# RECALL CAMPAIGN

CR5136ER1

SUBJECT:	Power Steering
JUSTIFICATION:	Certain power steering pipes may separate at the connection joint. This may cause a power steering assist lost and power steering fluid spillage from the ceiling in the cabin.

Figure 5 - Hydraulic Pipe N77549-01

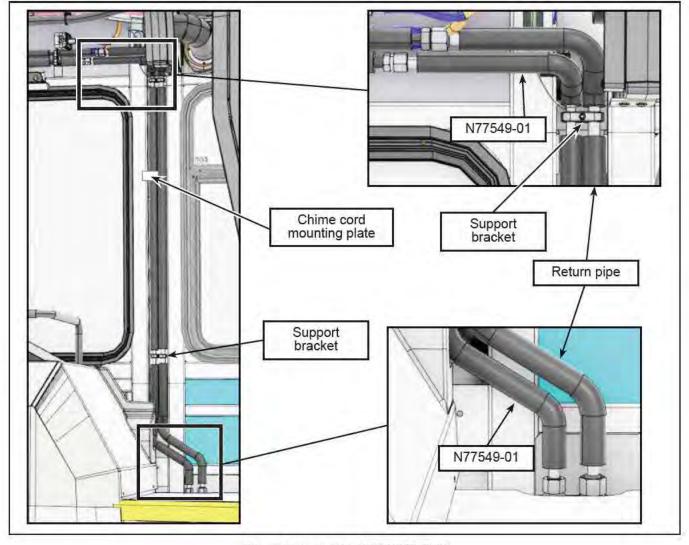
- 1.16. Locate hydraulic pipe N77549-01 (Figure 5).
- 1.17. Remove the 2 support brackets.
- 1.18. In order to remove the hydraulic pipe N77549-01, it is necessary to first remove the return hydraulic pipe located next to it because of the presence of the chime cord mounting plate.
  - a. Disconnect the ORS fitting at each end of both pipes (note: a small amount of oil will pour).
  - b. Remove the return pipe.
  - c. Remove the pipe N77549-01.

- 1.19. Install new insulation N26360 on the new hydraulic pipe N77549-01 as on the old one.
- Install the pipe N77549-01 in the vehicle and hand tighten the ORS fittings.
- Reinstall the return hydraulic pipe and hand tighten the ORS fittings.
- 1.22. Tighten the 4 ORS fittings to the torque value of 48 lb-ft (65 N·m).
